## Product / Process Change Notification (PCN)

**PCN #:** PCN\_IndHIDA\_20200513  
**Affected Series:** WE-HIDA; 7444011715xxx

**PCN Date:** April 15, 2020  
**Effective Date:** May 15, 2020

### DETAIL OF CHANGE:

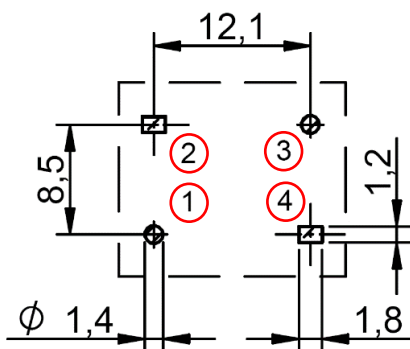
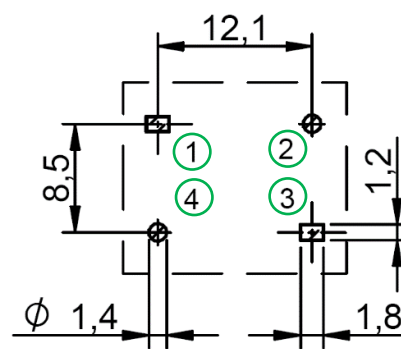
Because of a database mismatch, Würth Elektronik will correct the pin numbering of the "Recommended Hole Pattern" and the Schematic.

This is a datasheet correction only. There will be no change in form, fit, function, quality or reliability of the product.
